Brief report on S73 changes below :

Access Road Changes

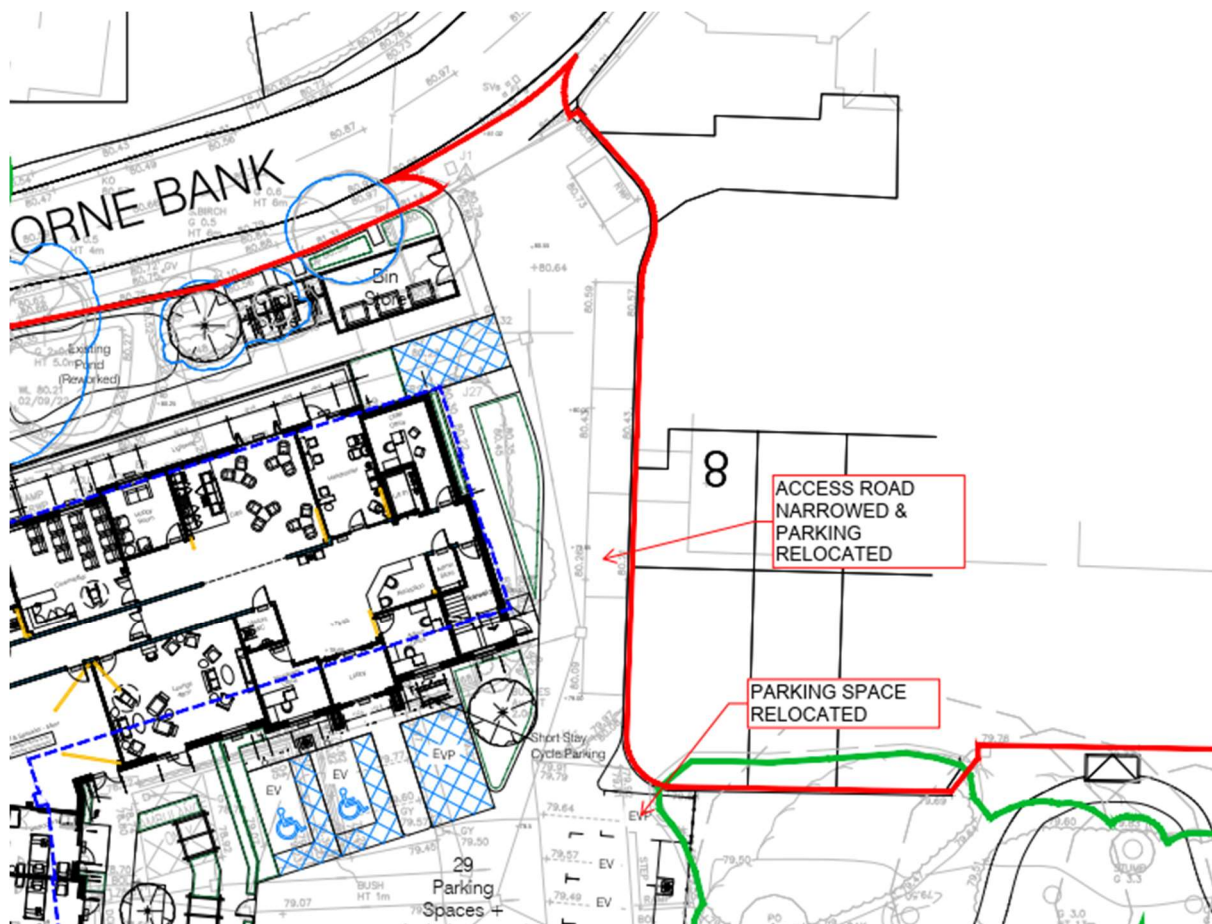
The planning approved scheme indicates the access road from Copthorne Bank tight against the boundary wall (and garage) of No. 8 St Francis Gardens.

The proposed FFL of the care home is indicated as 78.650m

The existing ground level adjacent to the boundary wall is around 80.000m (varies)

To constructed the planning approved scheme this would necessitate lower the ground levels adjacent to the wall and garage approximately 1.0m. This would necessitate underpinning and or demolition and rebuild which is disruptive.

In order to alleviate this issue, the access road has been narrowed and moved away from the boundary wall. The parking spaces immediately adjacent to the boundary wall has been relocated.

The section 73 proposed car park layout has been narrowed and lengthened to reduce the amount of proposed surfacing within the tree root protection zones and accommodate the relocated parking spaces.
